**PENINSULA TOWNSHIP
SPECIAL MEETING
PLANNING COMMISSION
AGENDA**

SPECIAL USE PERMIT
FINDINGS OF FACT

SUP #127, Vineyard Ridge (Planned Unit Development Condominium Subdivision)

1. SLOPES OF 1:3 OR LESS
 WHERE SLOPES RESULTING FROM UNIT DEVELOPMENT
 AREA 1:3 OR LESS, EXPOSED SOIL WILL BE STABILIZED
 WITH SEED AND MULCH

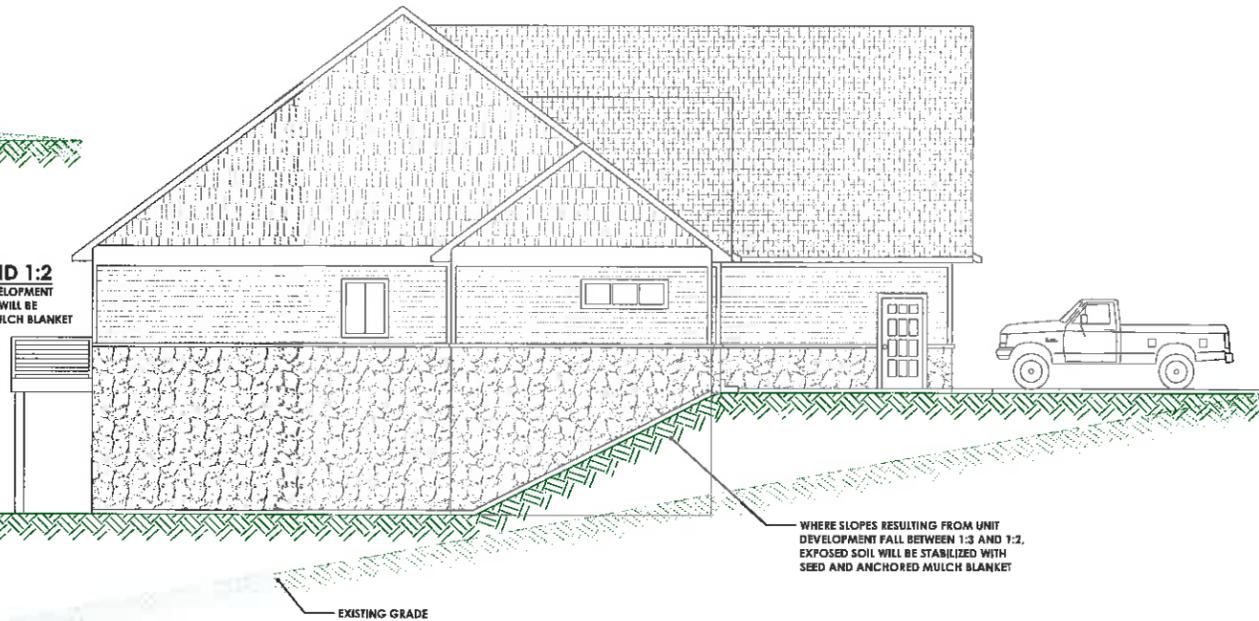
The typical stabilization preliminary plan for the individual sites that you provided to me for comments, I approve what you have shown, it gives different stabilization options. I want to reaffirm too all parties involved that it was not my intent indicate that the sites were not build able , I only wanted to point out and inform all it may take more than just grade the site and plant grass to stabilize the site. Some of the sites may need permanent SESC Measures installed.
Questions, Please Call

I did not want to indicate that the sites were not suitable for building Homes.l sites, I just wanted to make all parties aware from my point of view that planting grass alone for lawns after the final grading is done my not be the only permanent SESC measures needed to stabilize the site.

That attachment just contained typical cross-section details. However, I would like to see grading details on the plans similar to what we asked for and provided on The 81. Below is comment Item 5 of Grading and Paving in our June 8 review letter:

“Detailed grading and drainage pattern information needs to be provided on the plans for all building sites. In addition to finished floor elevations, spot elevations, slopes, and drainage direction arrows need to be provided for driveways, side yard/rear yard swales. Information needs to be provided to clearly show that surface drainage is handled in a controlled manner for positive drainage. “

We need the detailed grading information on the plans to provide an overall framework that individual building sites will need to conform so we know the sites function with respect to the proposed road, adjacent building sites, and drainage.
